Interactive comment on “Toward seamless hydrologic predictions across scales” by Luis Samaniego et al.

Luis Samaniego et al.

Received and published: 1 May 2017

Fig. 1. Fields for the "Beta" parameter estimated for HBV and mHM. We consider that obtained with mHM and MPR a seamless field.

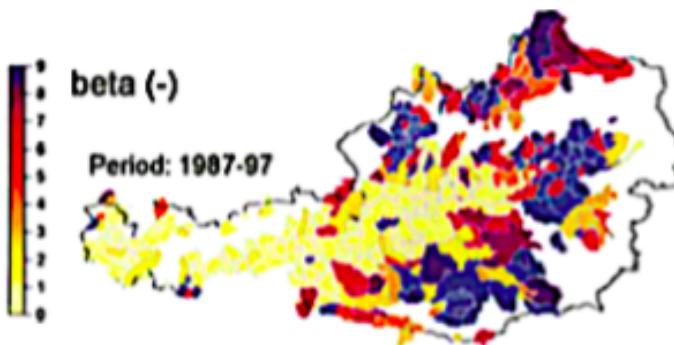
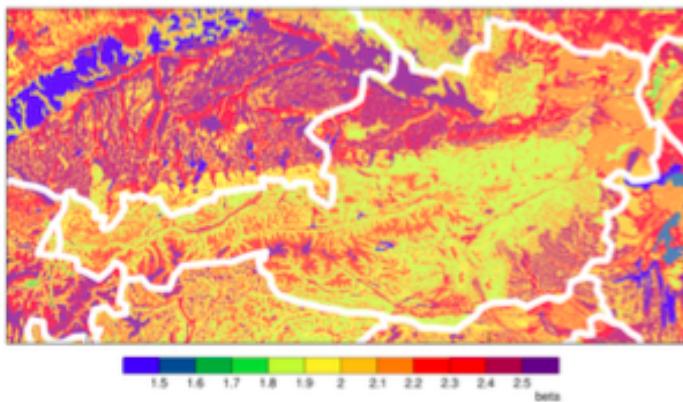
6. *p.5,l.19 and elsewhere in the manuscript: much is made of "discontinuities". However, the authors do not provide a clear definition of what they mean. Nature is, in places, discontinuous (e.g. forest vs. grassland, north vs. south aspect, sharp transitions in geology, breaks topography, etc). thus it is not clear why models should not represent these discontinuities. I suppose that the authors want to say that between individually calibrated catchments discontinuities can occur, where there are in reality no discontinuities. But this needs to be made clearer.*

An example of artificially induced discontinuities by parameter calibration is

shown is Fig.4. We agree that there are natural discontinuities, we expect however, that it is unlikely that everywhere the model parameter and fluxes/state fields follow exactly the boundaries of the drainage area at a given location (see Fig.1 below). We call this negative effect calibration imprint, and we attempt to remove it with MPR. This artificial boundaries is what we call discontinuities. In the revised manuscript we will clarify our definition to avoid confusions. Nevertheless, we provide references to literature in p.5 l.19 to illustrate our definition. Please see the obtained parameter fields in Fig.1 (below) as obtained by Merz and Bloeschl 2004 and by MPR in Rakovec et al. 2016 JHM.
